Highgate Conservation Area Advisory Committee14/2/2025

Highgate CAAC objection to 2025/0229/P **Waterlow Park Highgate Hill N6 5HG** Provision of step-free access to Highgate High Street entrance to Waterlow Park, including alterations to gate supports.

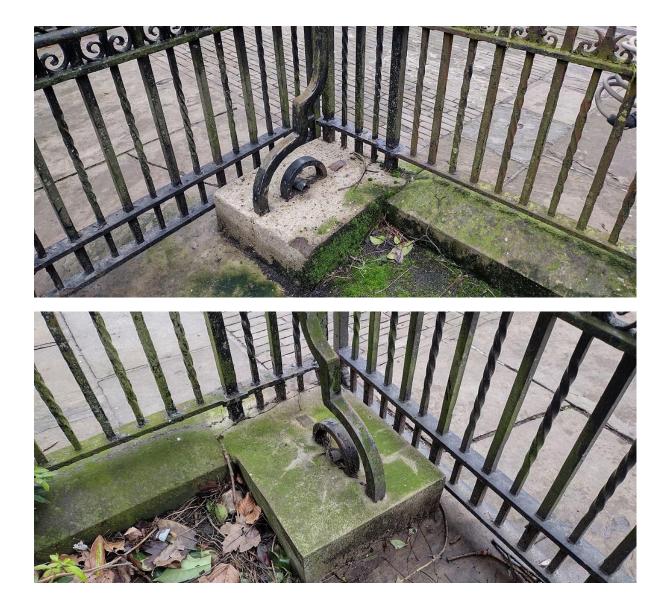
HCAAC members met twice onsite with the project officer. We believe we were clear that we thought the existing gates should not be altered as they were an integral part of a listed park and in a conservation area, but that lowering the York Stone Threshold and attaching a small fringe to the bottom of the unaltered gate to fill the gap, if need be, might be acceptable.
